# PUBLICATION INDEX FOR SGS 1-36

K & L SOARING, LLC  
5996 STATE ROUTE 224  
CAYUTA, NY 14824

BULLETIN NO. SA-001.6\*

SUBJECT: ONE-TIME INSPECTION OF TOW RELEASE ASSEMBLY; DAILY INSPECTION OF TOW RELEASE ASSEMBLY; PILOT'S PREFLIGHT INSPECTION OF TOW RELEASE ASSEMBLY; 100 HOUR/ANNUAL INSPECTION OF TOW RELEASE ASSEMBLY.

**FIGURE 1 – ENGAGEMENT OF TOW HOOK INTO RELEASE ARM**

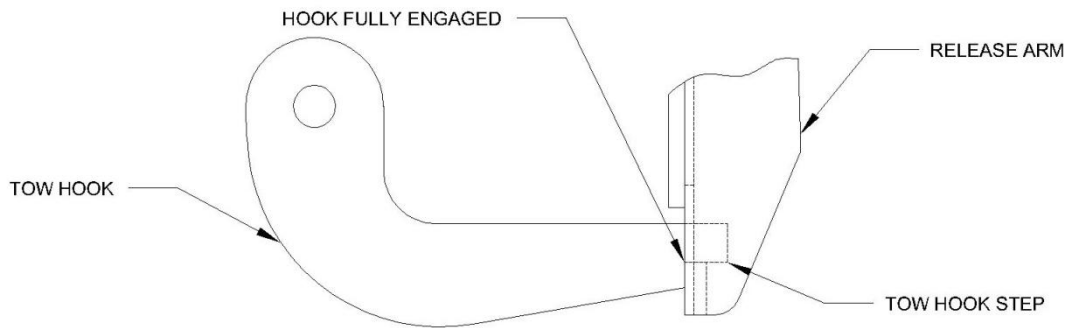
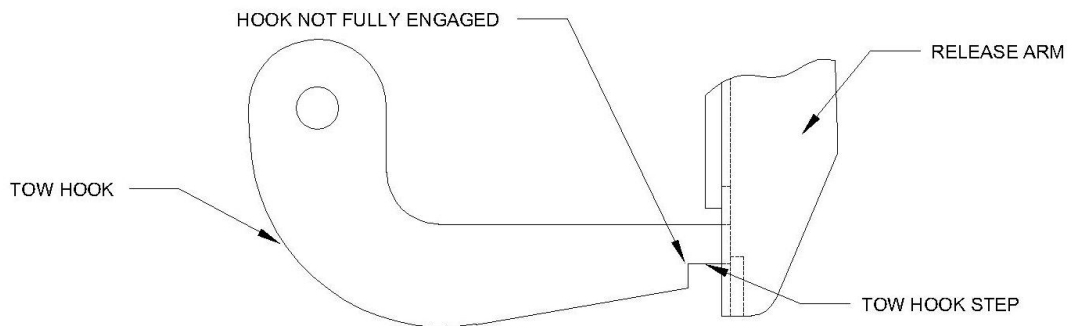
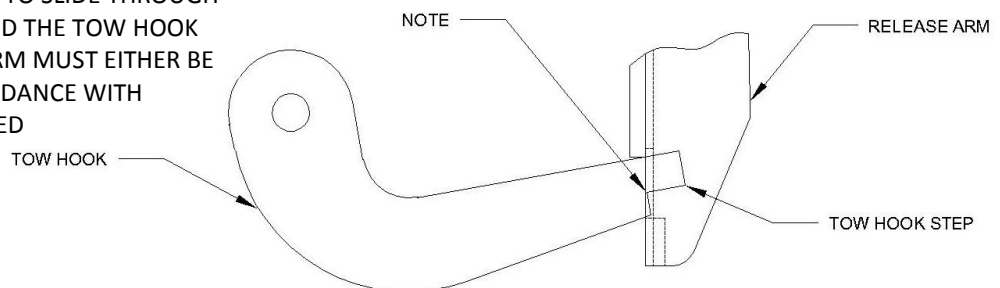
OVERVIEW: The .5 revision is the same as the .4 revision except changes to Figures 1, 3, & 4. Figure 1 has changed to add View D to show improper engagement. Figure 3 has been changed to show proper release arm cutout. Figure 4 has been changed to show proper readings for the C.G. hook install.

- g. If tow hook is able to travel too far inboard as shown in Figure 1, View C, disengage tow hook from release arm and measure the length of the release arm slot
- h. If dimension is less than 0.66 inch, rework release arm by welding on 1B-217-19 slug at location shown in Figure 3. (Release arm may be replaced as an alternate to welding on slug)
- i. If length of release arm slot is greater than 0.66 inch, replace release arm.
- j. Perform a thorough inspection of the tow hook installation in accordance with the 100 hour inspection requirements listed in Table 2 of this bulletin.
- k. Repair or replace unserviceable component(s), as required
- l. Record compliance with Part I of this Service Bulletin in Aircraft Log Book.

- Figure 1 shows the proper attachment of the tow hook into the release arm. Note that the step of the tow hook should seat against the release arm. The tow hook step must fully engage the release arm to allow the release assembly to function properly. The tow hook must not be allowed to extend through the release arm beyond the step on the hook as shown in Figure 1, View C.

IF TOW HOOK IS ABLE TO SLIDE THROUGH RELEASE ARM, BEYOND THE TOW HOOK STEP, THE RELEASE ARM MUST EITHER BE REWORKED IN ACCORDANCE WITH FIGURE 3, OR REPLACED

**FIGURE 2 – TOW HOOK INSPECTION AND REWORK (SHEET 1 OF 2)**

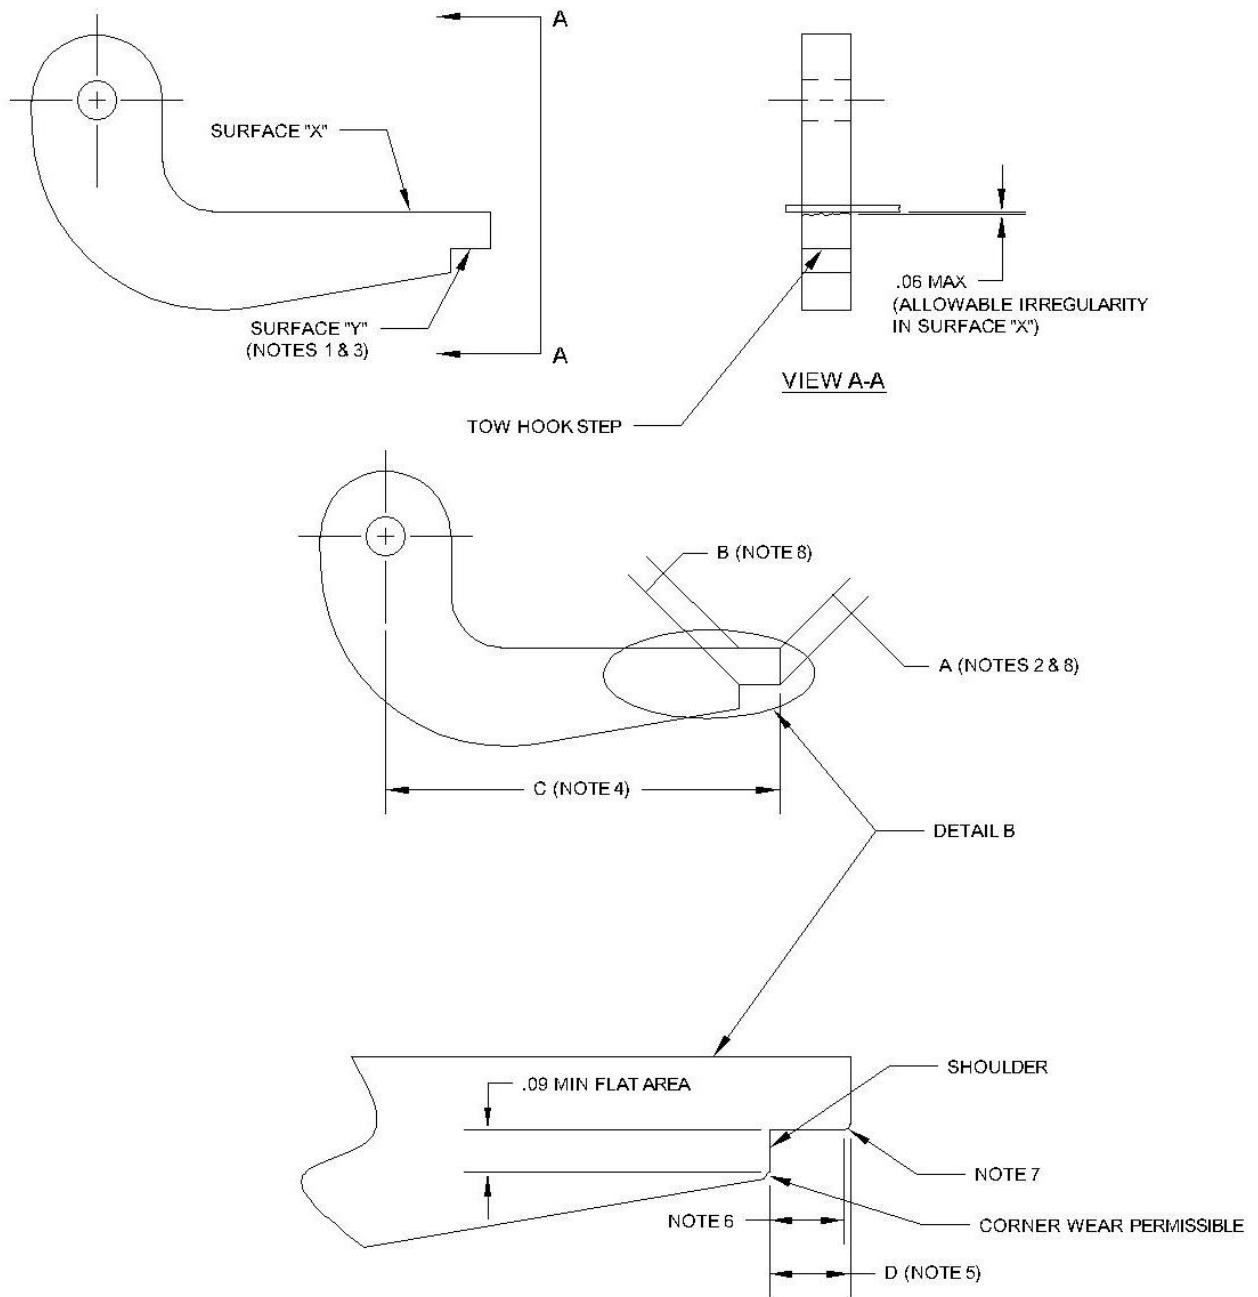
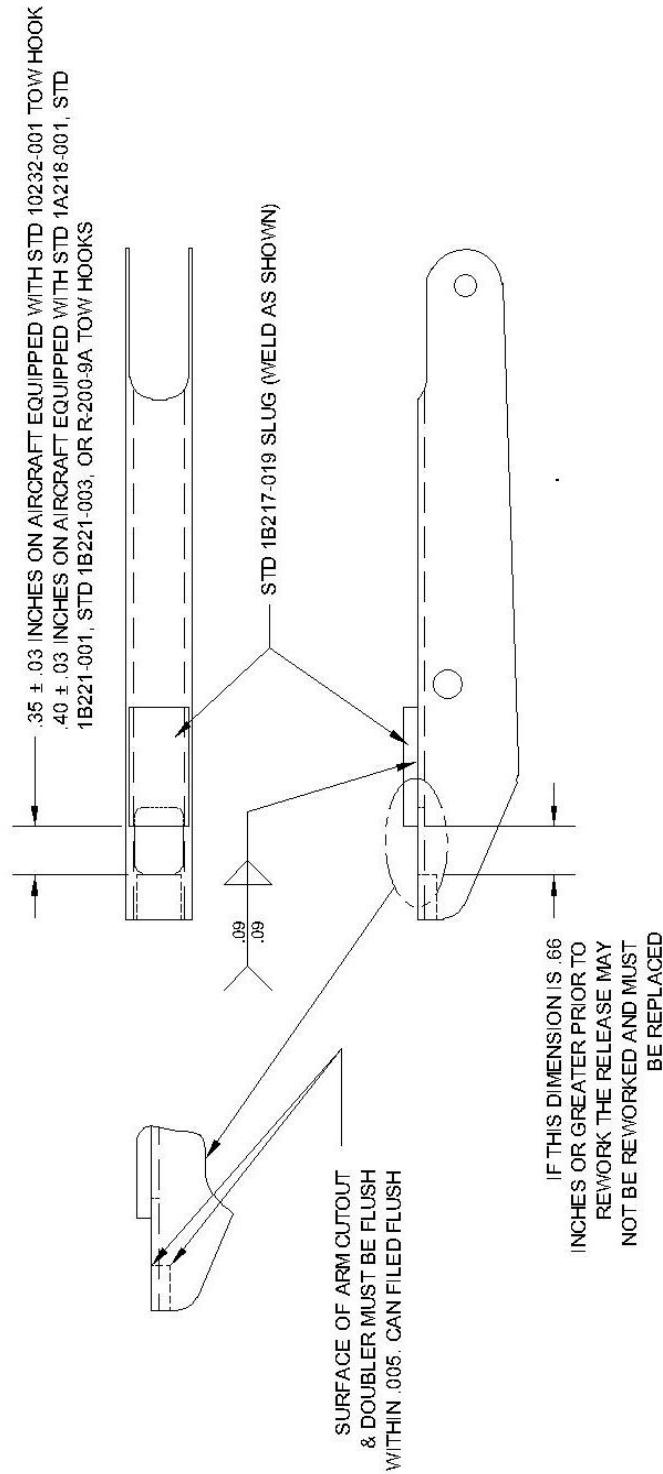
- Proper engagement of the tow hook into the release arm is shown in Figure 1, View A, and Figure 4. Excessive wear of the tow hook step could result in improper engagement. Figure 2 of this bulletin provides inspection data and wear limits for the tow hook. Tow hooks which do not meet the specified limits must either be reworked to obtain dimensions (as specified in Figure 2) or replaced.
  - If tow hooks is able to slide into the release arm, beyond the tow hook step, as shown by Figure 1, View C, the release arm must either be reworked with a slug as specified in Figure 3, or replaced.
- c. Inspect tow hook for wear in accordance with Figure 2 of this bulletin.

- d. If tow hook dimensions are not within limits specified in Figure 2, either rework the tow hook to obtain dimensions (as specified in Figure 2) or replace it with a new or serviceable, used tow hook
- e. Engage tow hook into release arm. Ensure that the tow hook properly engages as shown in Figure 1, View A.
- f. If tow hook is unable to completely engage (shown by Figure 1, View B) shorten the rubber bumper stop between the release knob and the instrument panel to allow the release assembly to close further.

1. IF WEAR OCCURS ON SURFACE "Y" IT MUST BE POLISHED FLAT WITHIN TOLERANCES PROVIDED IN FIGURE 2 (SHEET 1). IF THE HOOK CANNOT MEET THESE REQUIRED DIMENSIONS IT MUST BE REPLACED. UNDER NO CONDITIONS SHOULD SURFACE "X" BE POLISHED OR MACHINED TO CHANGE ITS ANGLE.

2. DIMENSION "A" ON STD 10232-001 HOOK SHALL BE .21 INCHES MIN. & .28 INCHES MAX. DIMENSION "A" ON STD 1A218-1A, STD 1B221-3, & R-200-9A HOOKS SHALL BE .25 INCHES MIN. & .31 INCHES MAX.

3. SURFACE "Y" MUST REMAIN FLAT, SMOOTH, AND WITHIN TOLERANCES SHOWN ON SHEET 1. (SEE ILLUSTRATION).
4. DIMENSION "C" ON STD 10232-001 HOOK SHALL BE  $2.06 \pm .03$  INCHES. DIMENSION "C" ON STD 1A218-1A, STD 1B221-3, & R-200-9A SHALL BE  $3.00 \pm .03$  INCHES.

5. DIMENSION "D" ON STD 10232-001 HOOK SHALL BE  $.25 \pm .03$  INCHES. DIMENSION "D" ON STD 1A218-1A, STD 1B221-3, & R-200-9A SHALL BE  $.31 \pm .03$  INCHES.

6. HOOK MUST REMAIN FLAT IN THIS AREA FOR A MIN. OF .21 INCHES FROM SHOULDER OF HOOK.
7. WEAR OUTSIDE OF THE .21 MIN. FLAT AREA IS PERMISSABLE.
8. DIMENSION "B" MUST BE EQUAL TO DIMENSION "A", OR LESS THAN DIMENSION "A" BY NO MORE THAN .015 INCHES AND CANNOT BE GREATER THAN DIMENSION "A".

9. ALL SURFACES EXCEPT SURFACE "X" MAY BE FILLED TO OBTAIN REQUIRED DIMENSIONS.

FIGURE 4 - PULL TEST OF TOW RELEASE ASSEMBLY

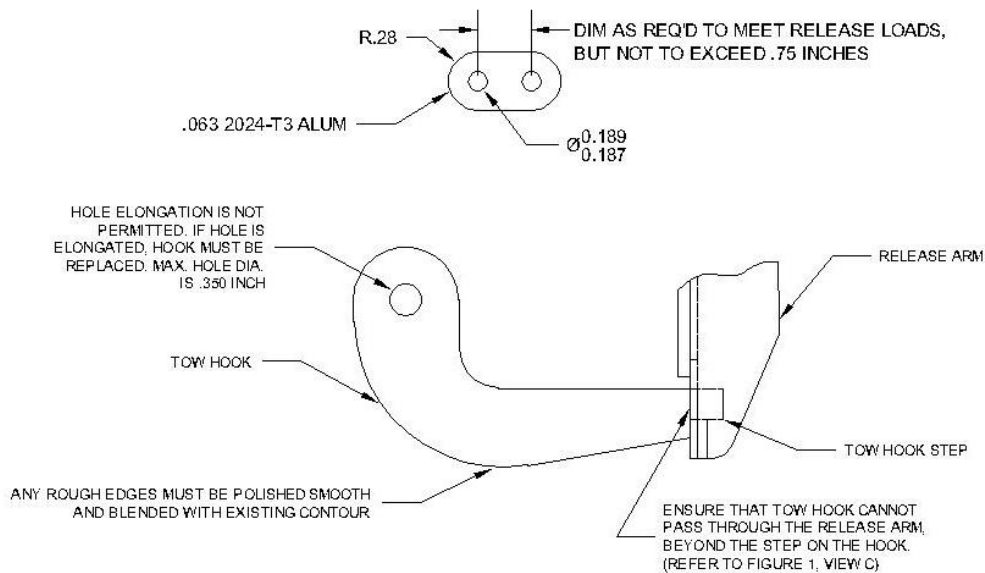
Perform a release check for proper release tension in accordance with Figure 4.			X
Lubricate attach hardware for tow hook and release arm.		X	X
Lubricate guide-tubes in release control with dry stick type lubricant.		X	X
Insure that tow hook moves freely on pivot bolt.	X	X	X

NOTE: IF RELEASE LOADS ARE TOO HIGH WITH C.G. SYSTEM IT IS PERMISSIBLE TO ADD A LINK TO SHORTEN STD 1A141-2 SPRING. LINK SHOULD BE MADE AS SHOWN BELOW. IF REQUIRED THEY SHOULD BE ADDED TO BOTH RELEASE ARMS TO BALANCE BOTH RELEASE SPRINGS

FIGURE 1

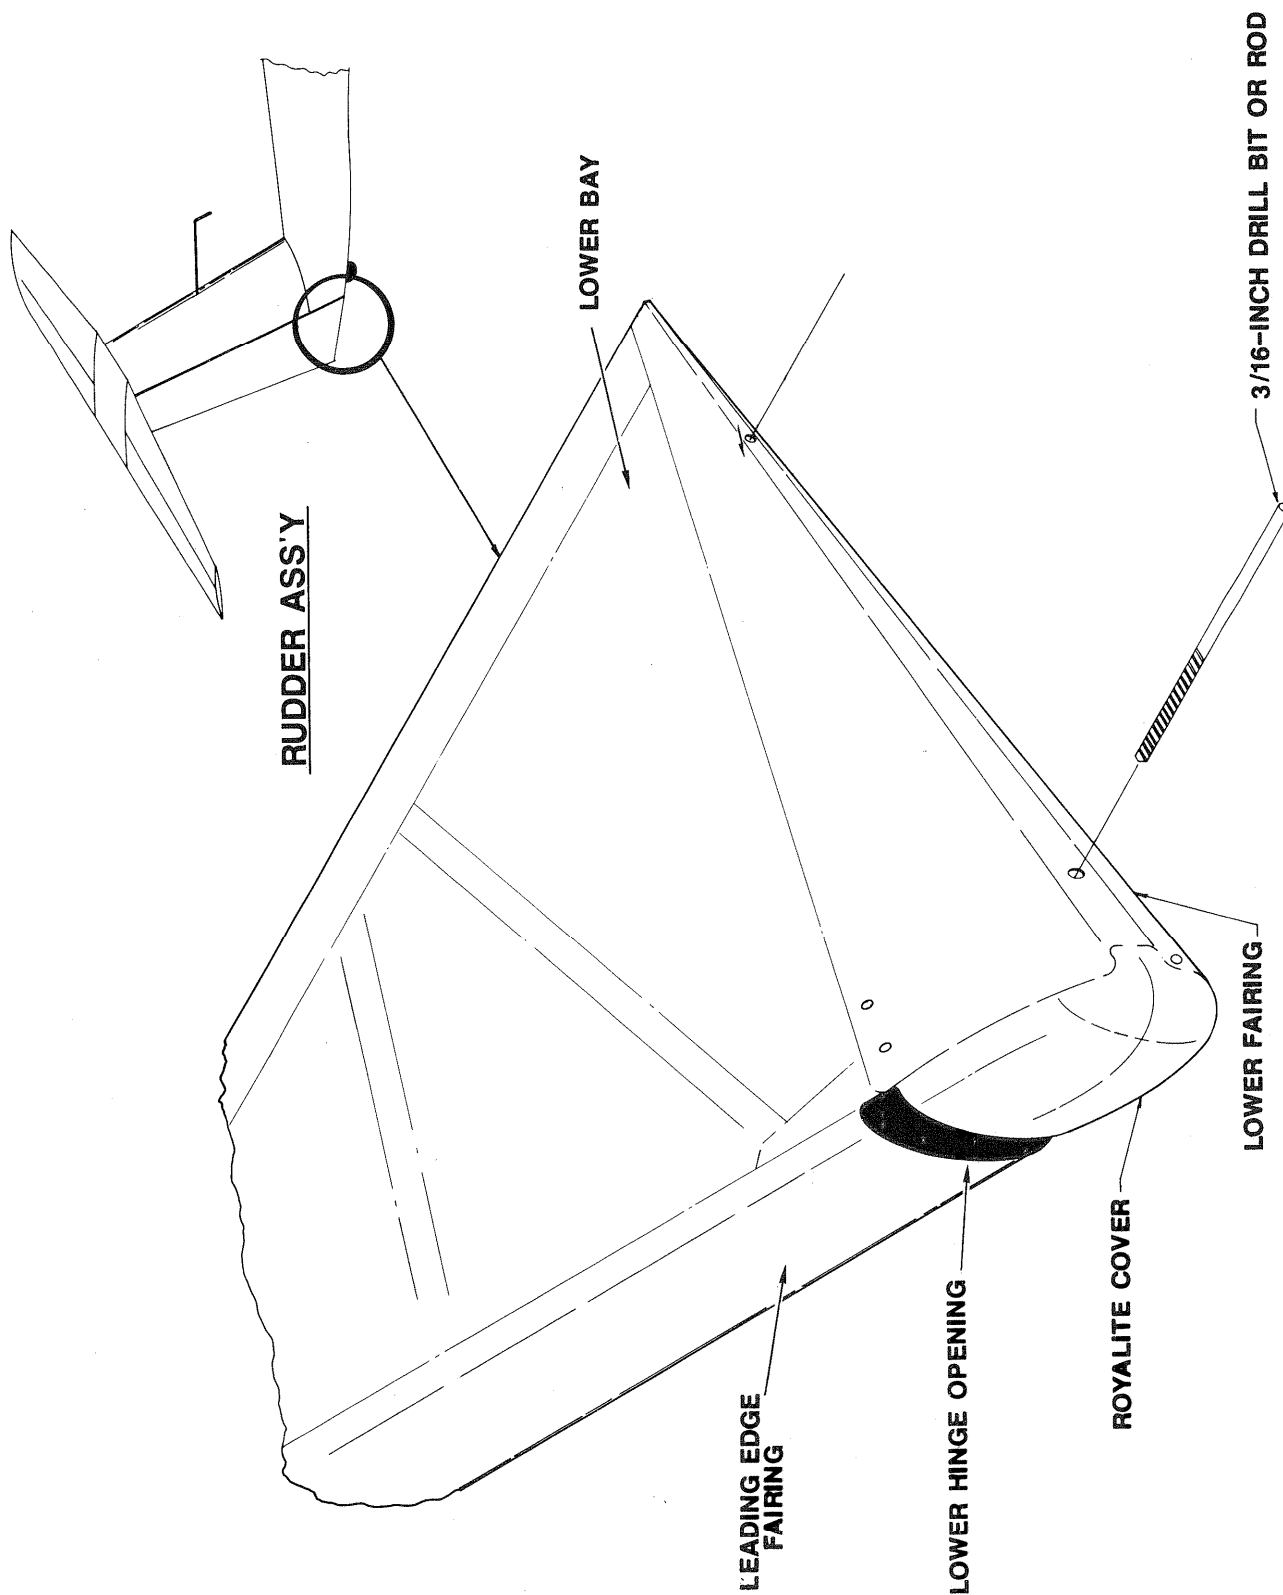
- b. Inspect all hinges, air vents, and aircraft openings for straw, weeds, sticks or any other obstructions. Pay particular attention to hinge and pushrod openings around the tail fin, tail rudder and elevators. Remove obstructions as required.
- c. Inspect for debris inside of tail rudder lower fairing (Figure 1) as follows:

- (1) Carefully adjust rudder position to extreme left or right.
  - (2) Using a flashlight, inspect for debris inside lower fairing (Figure 1) by looking through lower hinge opening.
  - (3) If debris is found, use a vacuum cleaner with flexible extension hose to remove debris.
  - (4) Check two drain holes (Figure 1) at bottom of fairing for obstruction. Clear obstructions with 3/16-inch drill bit.
- d. Open access door on horizontal stabilizer stub (Figure 2) and use a flashlight to inspect upper fin and stabilizer stub area for debris. Use vacuum cleaner to remove debris.
- e. Inspect brake/wheel area for obstructions. Remove obstructions as required.

Rodents may gain access and deposit debris at four different locations within the tail rudder. Debris may be present between the leading edge fairing and the spar, inside the lower fairing, inside of the lower bay or inside the upper bay. (Refer to Figure 1.) Each of these areas should be thoroughly inspected with flashlight and inspection mirror.

FIGURE 2

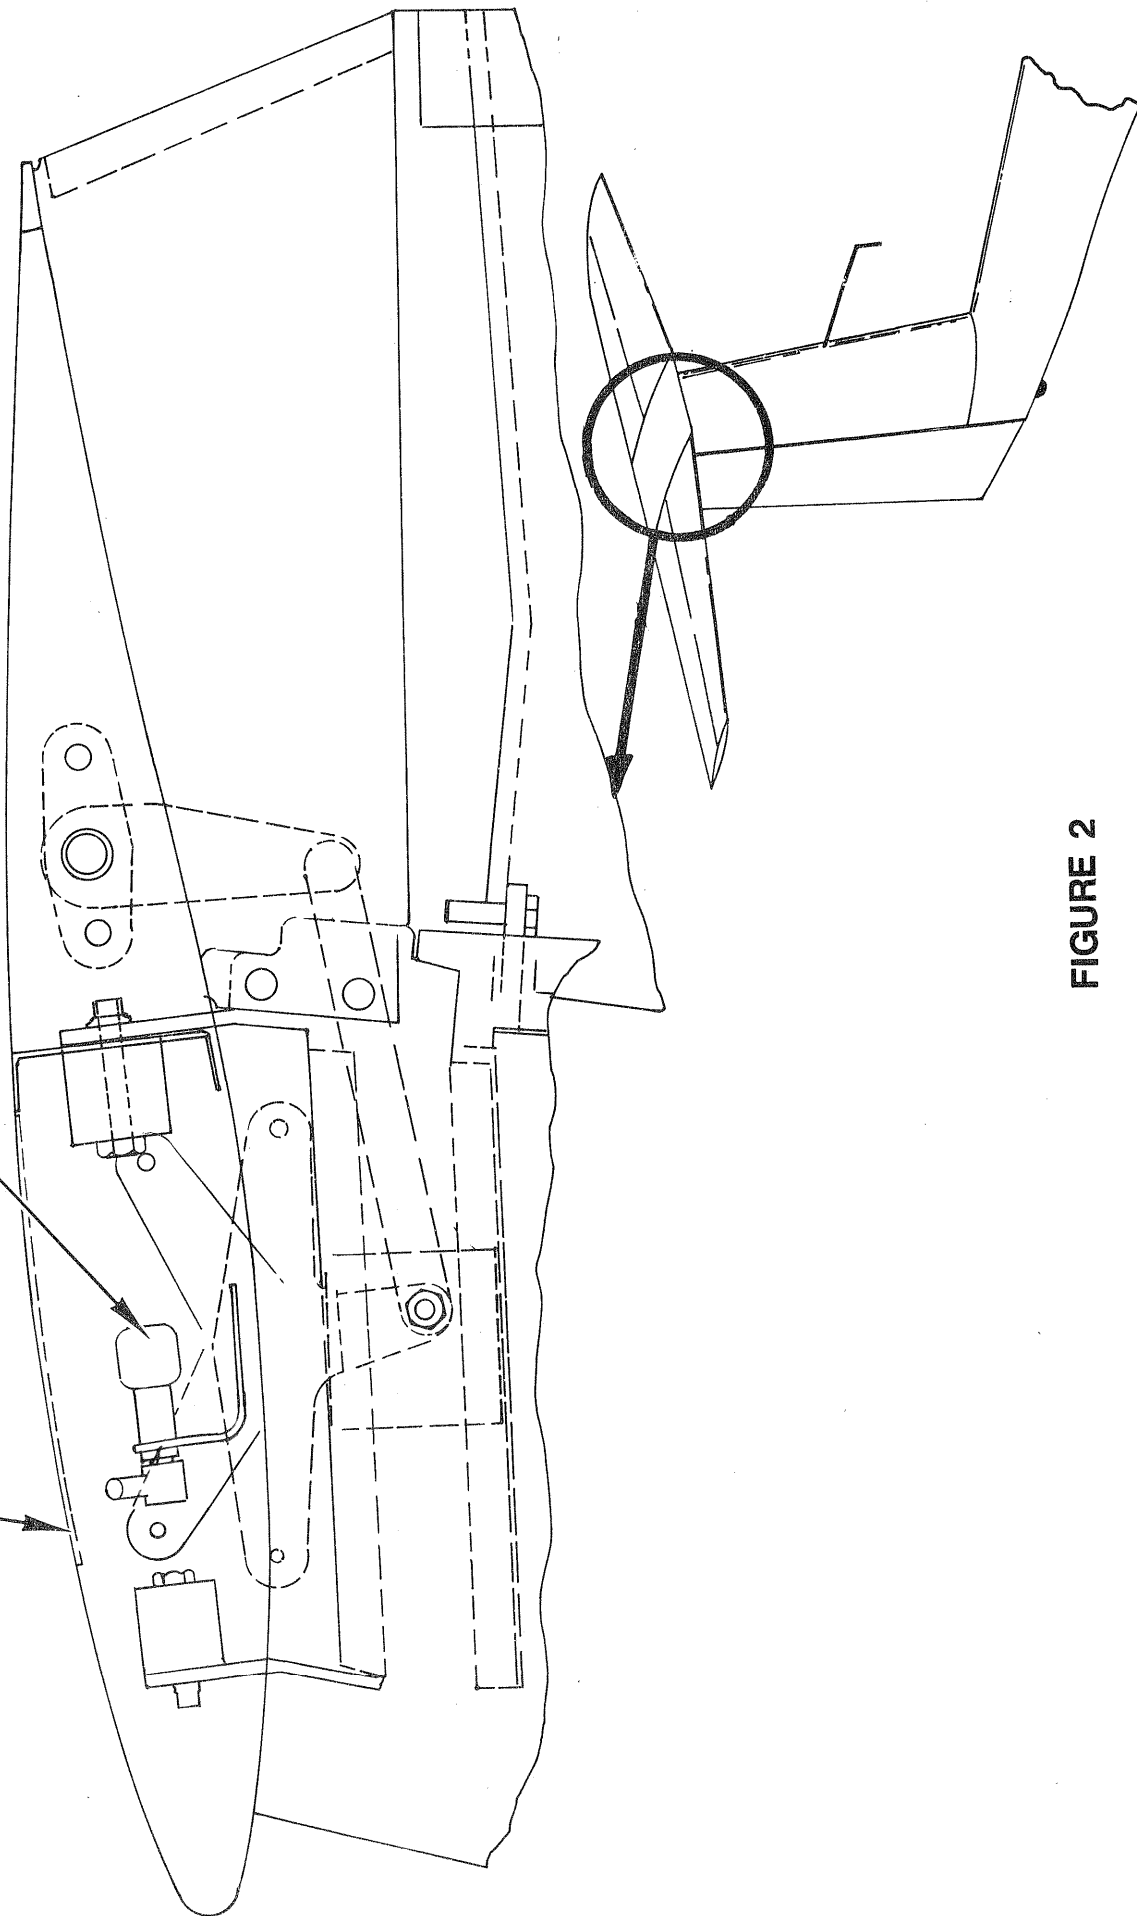
- h. Remove elevators from tail fin as follows:
  - (1) Open access door (Figure 2) on horizontal stabilizer stub.
  - (2) Remove pin securing elevators. (Refer to Figure 2.)
